RFI #041: Civil - Pedestrian Bridge Concrete Clarifications

Revision	0	Status	Open
To	Luke Arbanas (Nabholz Construction Corporation)	From	David Panto (Nabholz Construction Corporation)
Date Initiated	Sep 11, 2025	Due Date	Sep 18, 2025
Location	Civil Expansion	Project Stage	Pre-Construction
Cost Impact	TBD	Schedule Impact	TBD
Spec Section			
Drawing Number	S120, S211	Reference	
Linked Drawings			
Copies To	Don Kelley (Nabholz Construction Corporation), David Panto (Nabholz Construction Corporation), Vince Praderio (LITHKO CONTRACTING LLC)		
Priority			
Constraint

TYPICAL SECTION AT STEEL BEAM / RET. WALL

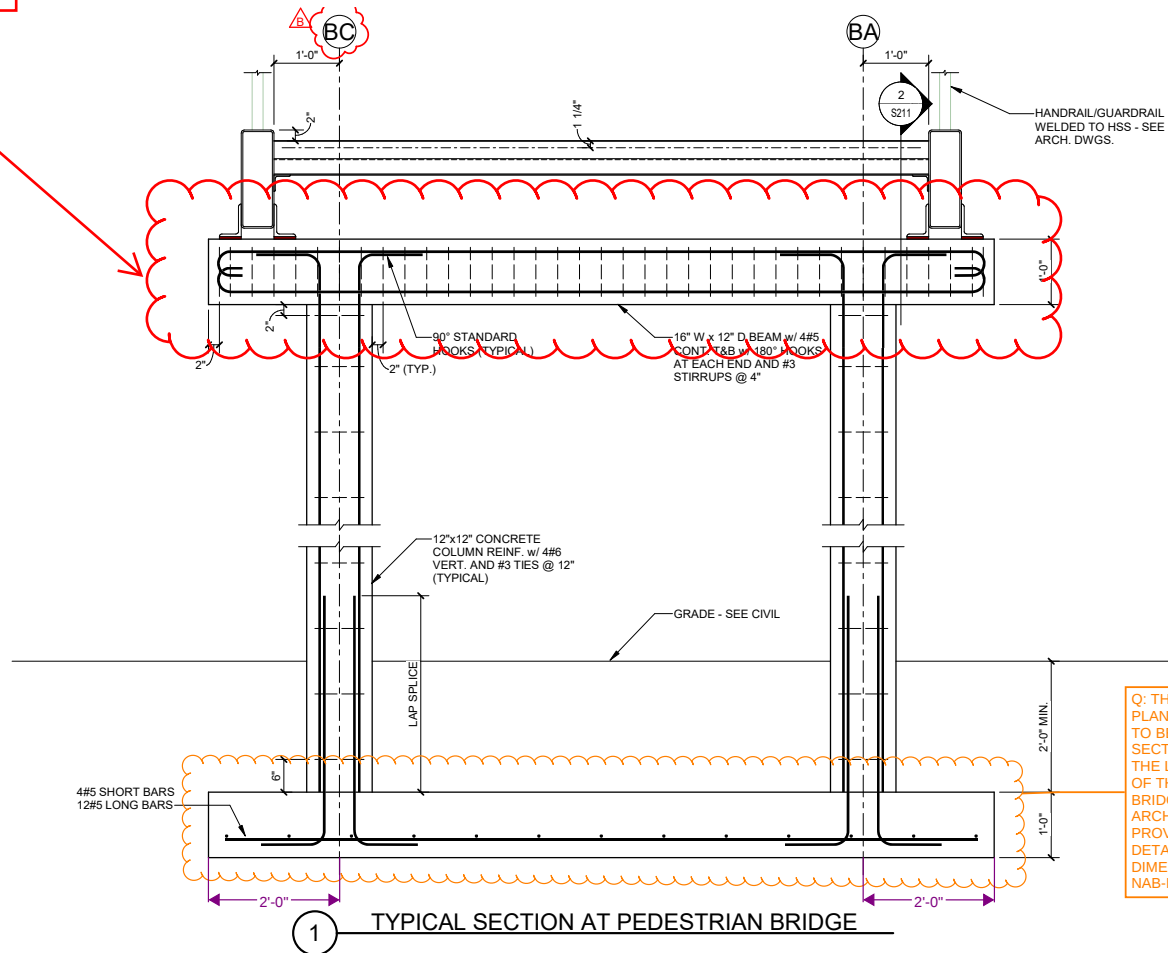
Q: THROUGHOUT THE PLANS, THERE APPEARS TO BE NO DETAILS OR SECTIONS IDENTIFYING THE LENGTH AND WIDTH OF THE PEDESTRIAN BRIDGE FOOTINGS. CAN ARCHITECT PLEASE PROVIDE SECTION OR DETAIL DEFINING THESE DIMENSIONS.
- NAB-MF-06.30.2025

What is this dimension?

What is this dimension?

GC Coordinate. 6 1/4" slab thickness + 18" HSS + 1 1/4" Min spacing + Bearing pad thickness. - SDL

8". -SDL
